ADDENDUM # 1

DATE: April 11, 2025

**FOR: PCDL – NEW LEXINGTON
ADDITION & RENOVATION**

A-220

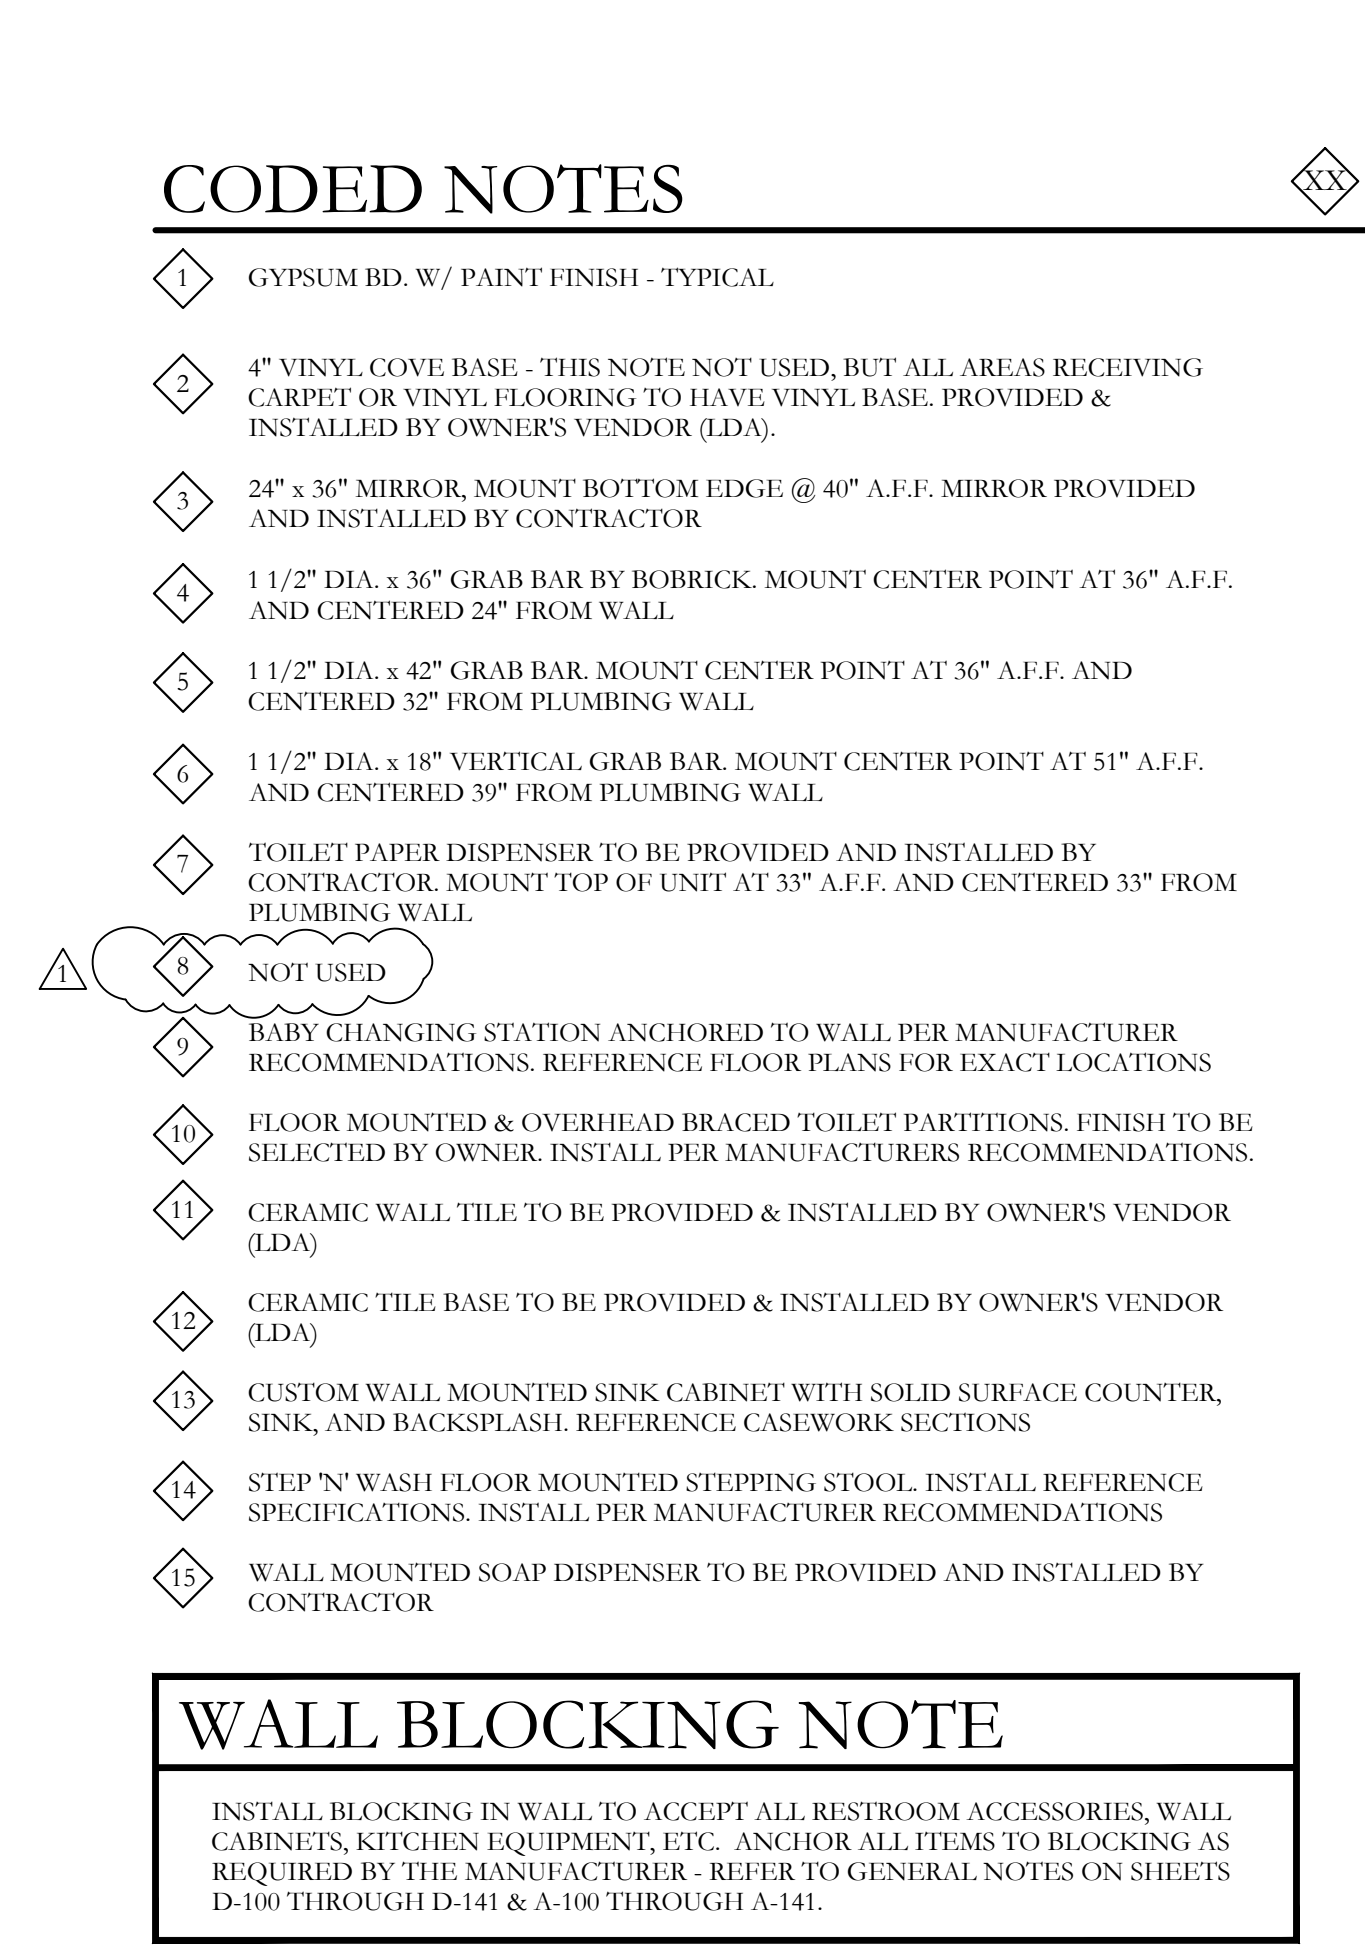
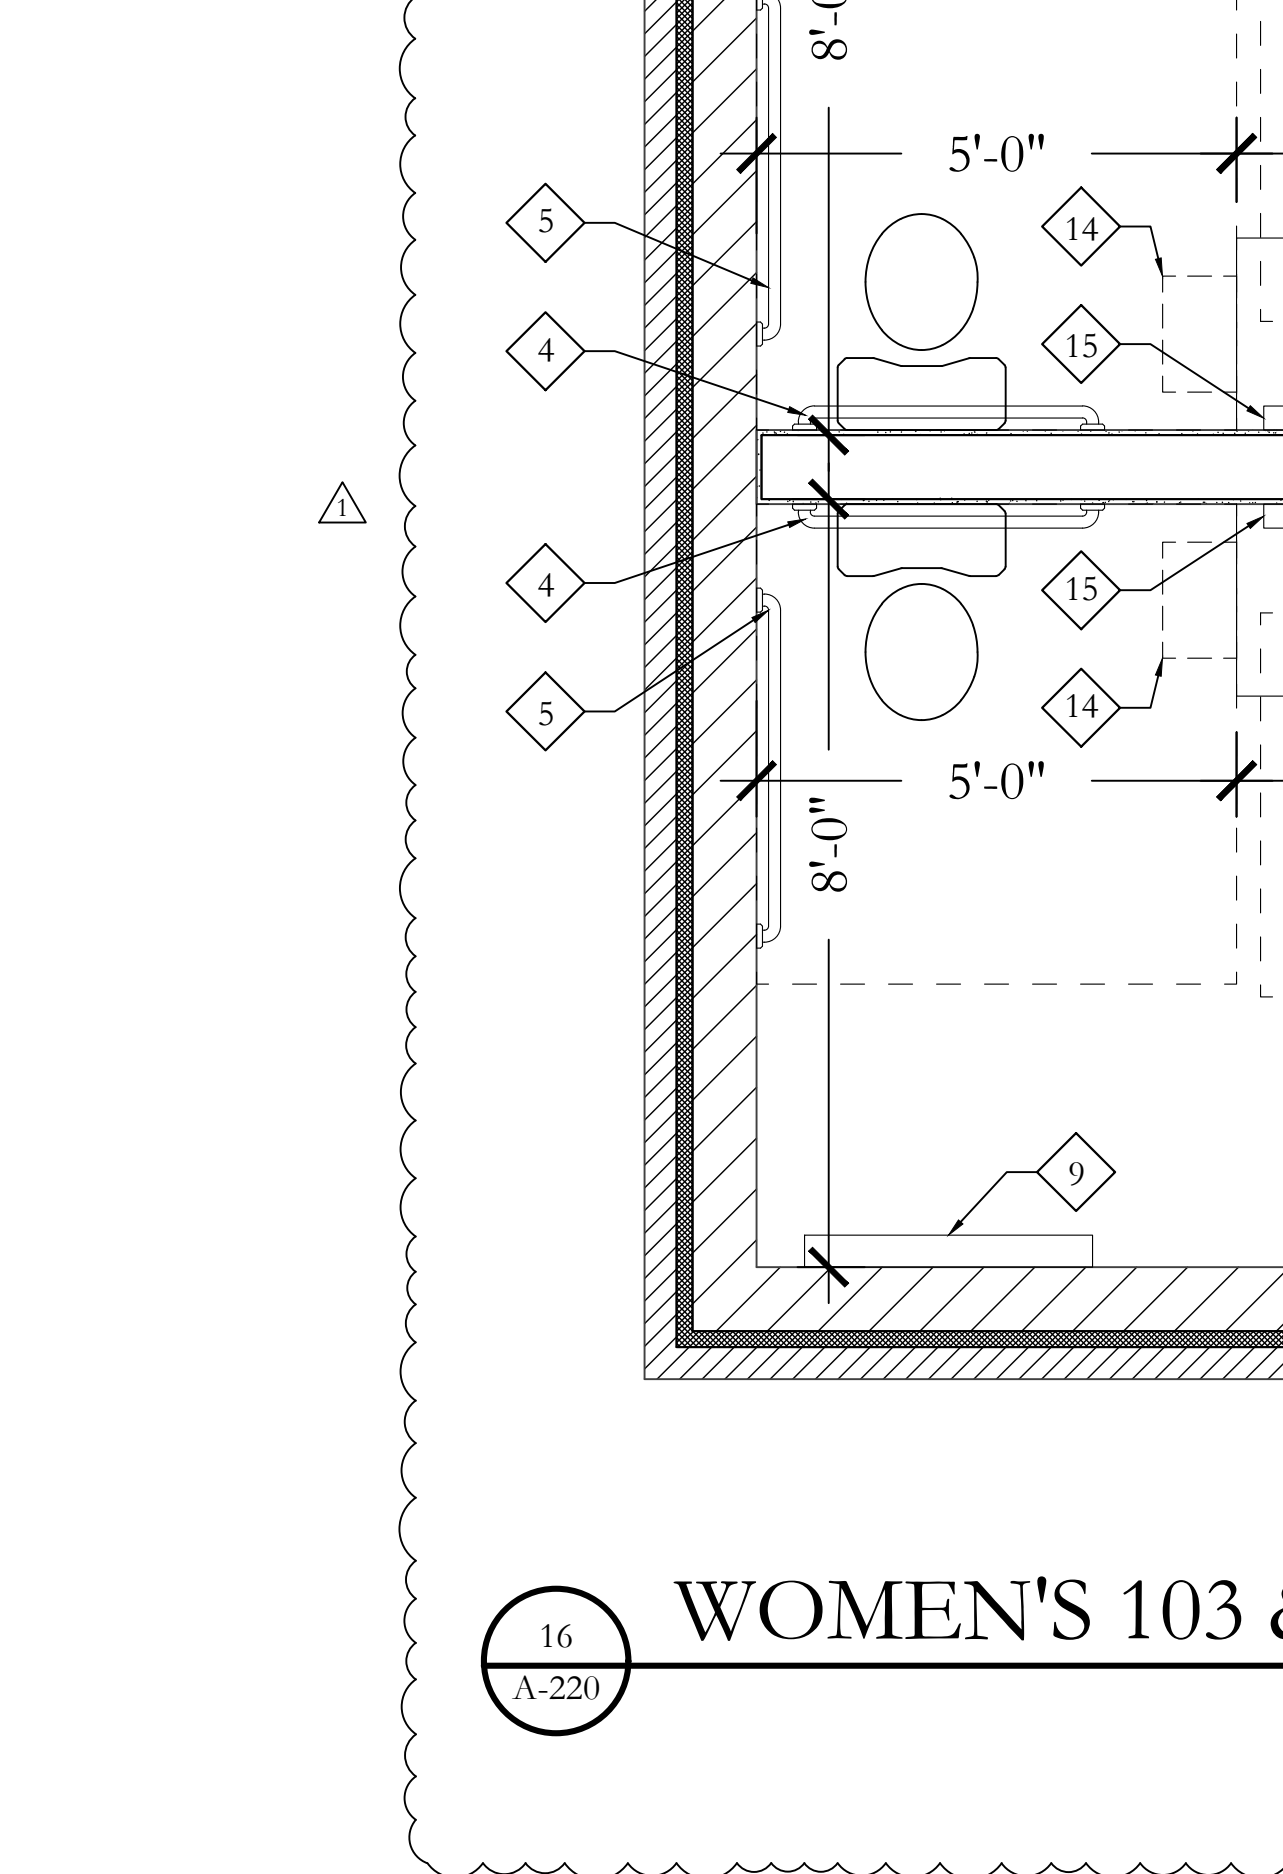
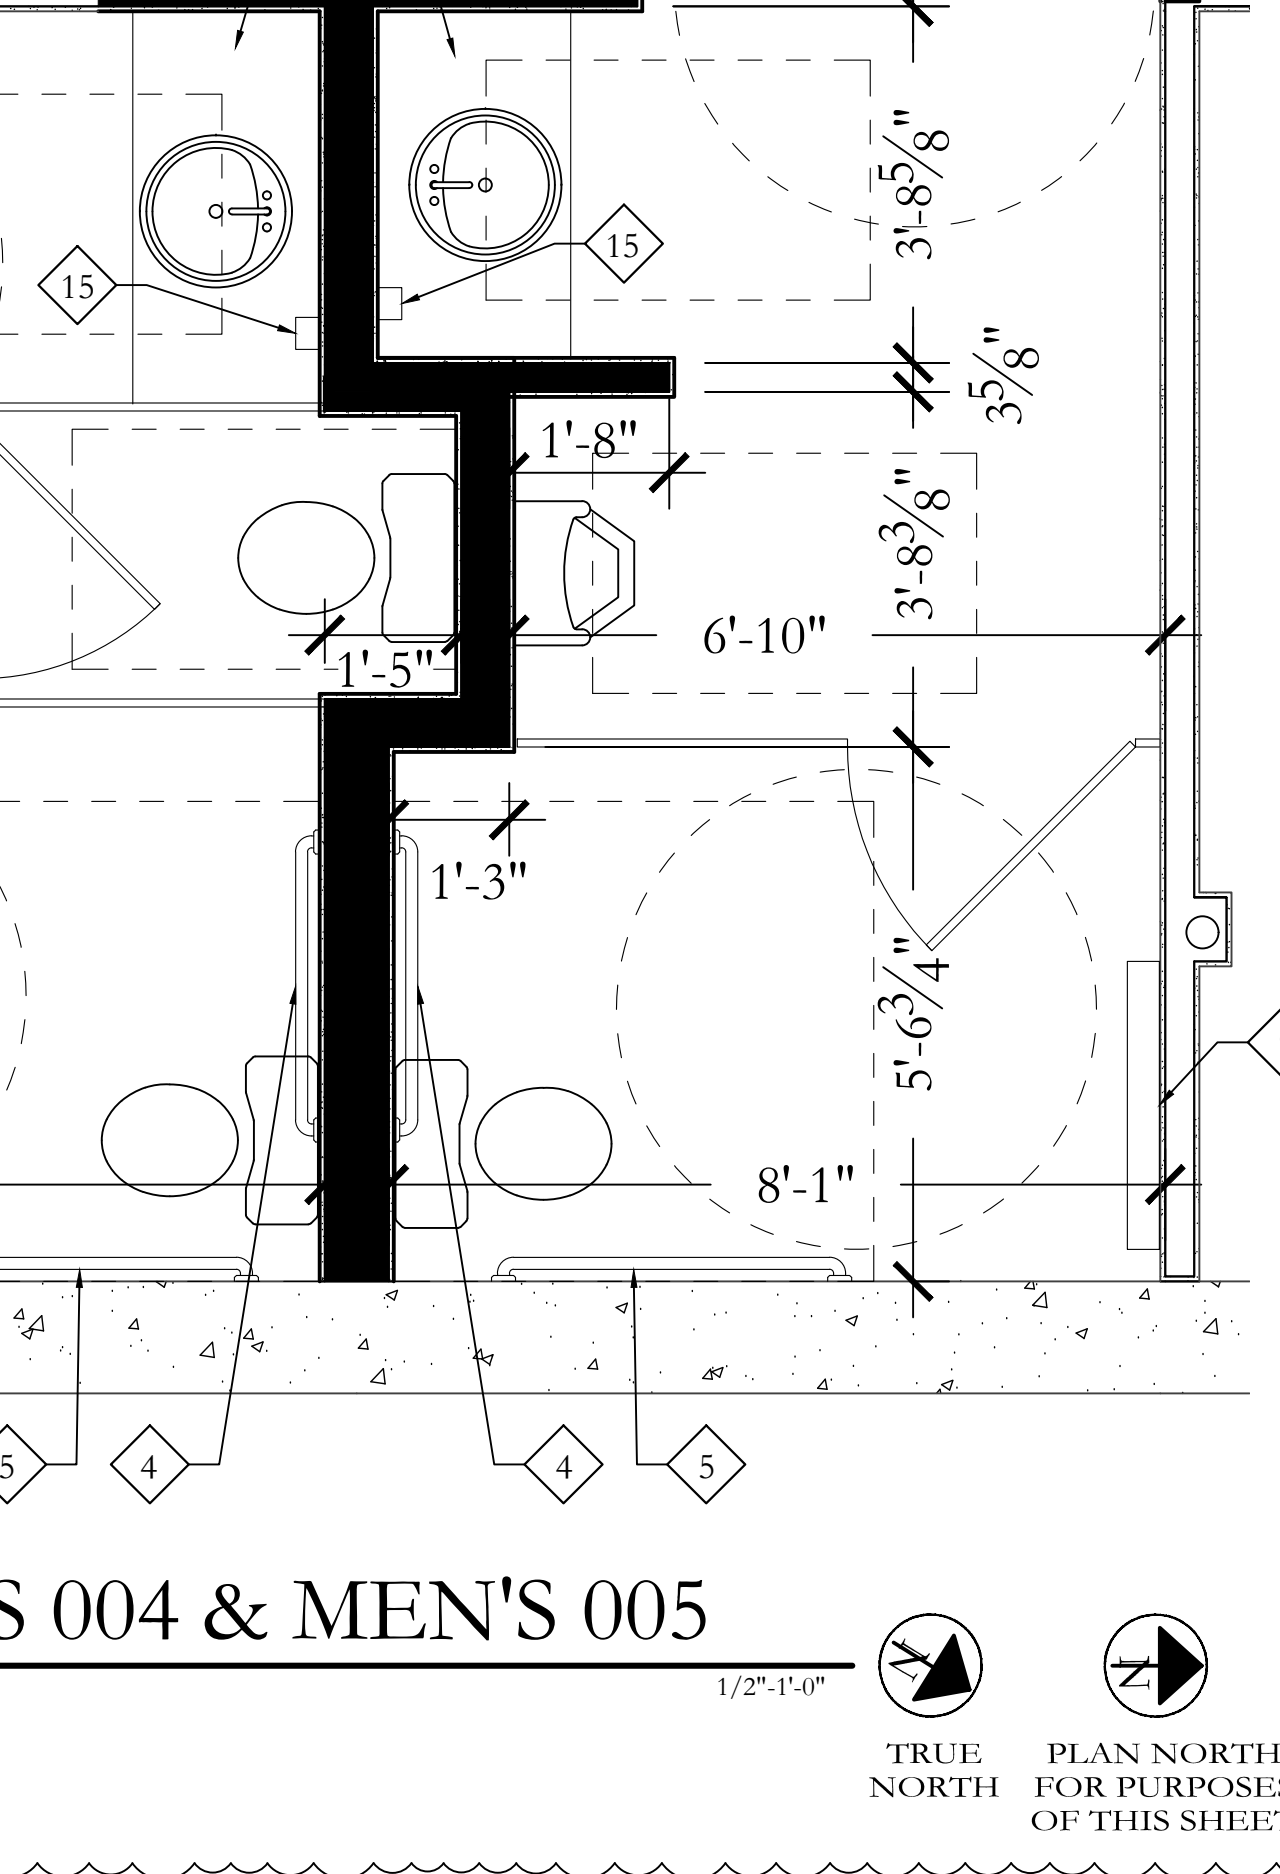
Item #8 Interior Elevations & Enlarged Floor Plans – replace A-220 with attached

- a. Remove paper towel dispensers in restrooms (Women's 004, Men's 005, Women's 103, Men's 104) – Owner will furnish paper towel dispensers, and Contractor will install.
- b. Revised coded notes
- c. Revised interior elevations (Details 1/A-220, 2/A-220, 5/A-220, 8/A-220, 10/A-220, & 11/A-220)
- d. Revised enlarged plans (Details 15/A-220 & 16/A-220)
